CALIFORNIA COASTAL COMMISSION

REGULAR CALENDAR
STAFF REPORT AND PRELIMINARY RECOMMENDATION

Application No.: 6-06-022

Description: Construction of a public pedestrian promenade, ranging in width from ten to fifty feet, along the South Shores area of Mission Bay Park, connecting with existing pathway components at either end.

EXHIBIT NO. 2
APPLICATION NO. 6-06-022
Site Plan
 California Coastal Commission

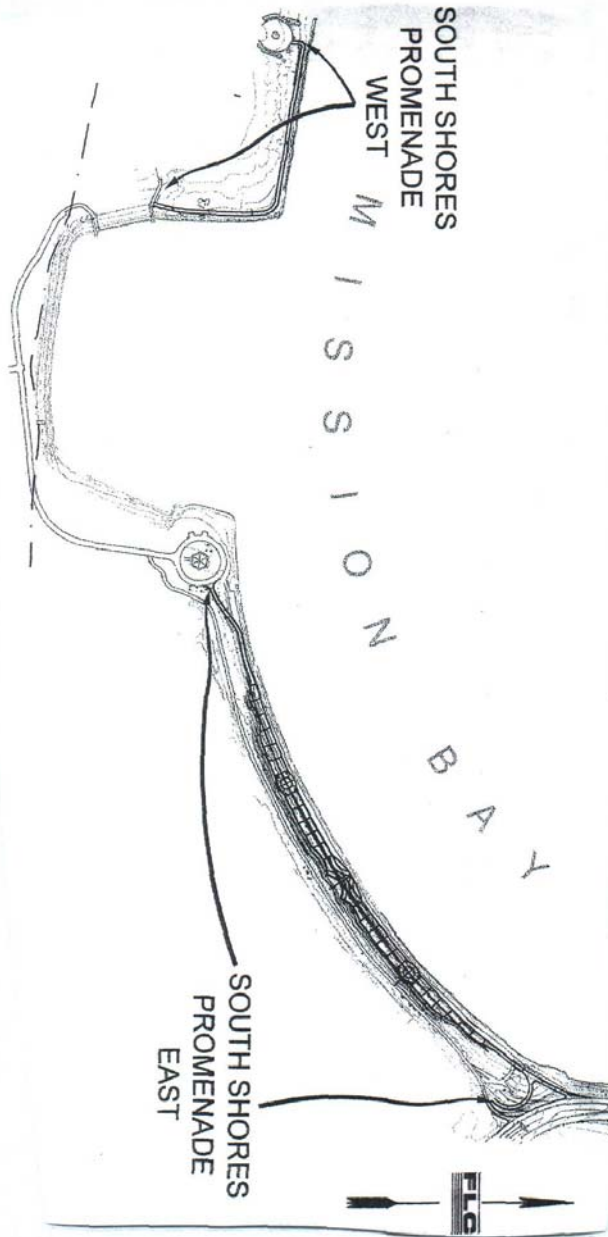
Lights are not proposed on the western walkway component closest to SeaWorld, but are proposed for the eastern component between the embayment and Fiesta Island. According to the submitted plans, the lights are proposed to be spaced approximately forty feet apart. Nothing identifies how closely spaced the existing embayment lights are, but there are eighteen existing lights at the embayment and ninety-four are proposed for the new promenade, yet the two areas are roughly the same length. Although it is possible that a greater concentration of lights may be needed at the largest gathering areas of the promenade to ensure public safety for evening events, nothing in the submittal supports this, nor does anything suggest that this is the case along the entire length of the promenade.

- a. Lights shall be placed on maximum 2-foot-high bollards.
- b. Lights shall be low-pressure sodium bulbs.
- c. All lights shall be shielded and directed downwards, such that minimal light falls outside the promenade boundaries.
- d. Where lights are required for public safety on only one side of the pathway, they shall be installed on the inland side only.
- e. The total number of lights shall be the minimum necessary for public safety, and shall not generally be spaced closer together than the existing lights at the embayment.
